REEL ASSEMBLY NO. 000F704Z (1291090)

SBT Ver. 050314 (Based on Penn's Rev 10 - 3-20-14)

Penn Reel Parts list for Model: 704Z

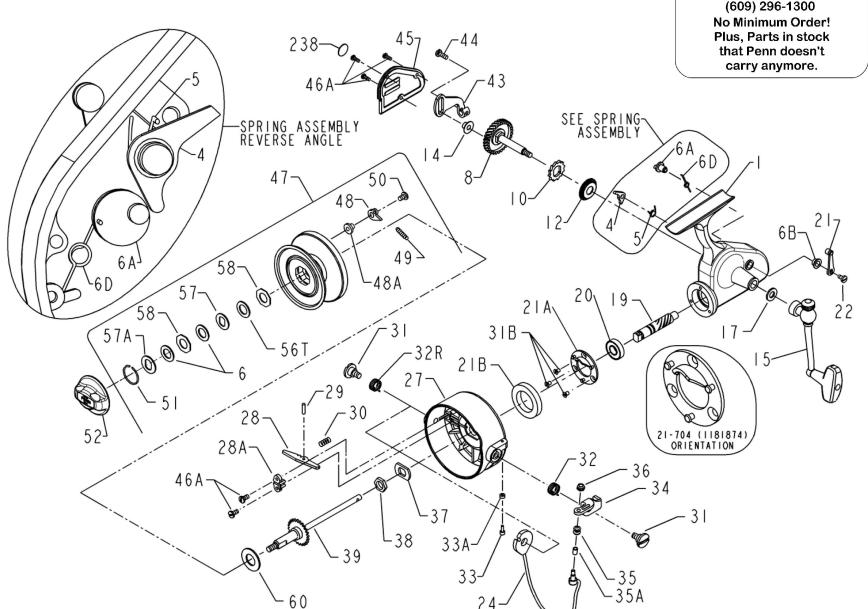
2	2-704		BUSHING				
19	19-704		PINION GEAR	19	19N-704	1181708	PINION GEAR (TEETH STOP WHERE PINION COVERED BY HOUSING
21	21-109		ECCENTRIC LEVER	21	21E-704	1320714	ECCENTRIC LEVER (JUST A 21-109 WITH A RUBBER SLEEVE ON IT)
27	27-704		ROTOR CUP (DECAL/GROOVE)	27	27N-704	1182273	ROTOR CUP (DOES NOT USE A DECAL)
47	47-704		SPOOL (COMPLETE)	47	47N-704	1183658	SPOOL (COMPLETE) (#50 and #57/57A only differences)
50	22-750		CLICK SCREW	50	48B-750M	1186969	CLICK SCREW (FLATTER STYLE HEAD)
57A	57A-750		METAL KEYED WASHER (2 REQ.)	57	57-704	1183937	METAL KEYED WASHER (1 REQ.)
				57A	57A-750	1183942	METAL KEYED WASHER (1 REQ.)

Biggest noticeable difference in the 2014 black/gold reels is the rotor cup goes back to the way the old green ones were, all smooth metal with no indent for the decals. It does not use rotor decals.

Note to owners of Penn Green series of Spinfishers.
All parts are interchangeable between the Green Series
and the New Z series except parts 1, 15, 27, 45, 47, 52."

TRANSLATION: 1, 15, 27, 45, and 52 were just differences in cosmetics - newer parts fit but are black. Only on 47- Spool does the difference become a problem, as the newer clicker does not seat the same. If you don't care about having the clicker, this isn't an issue.
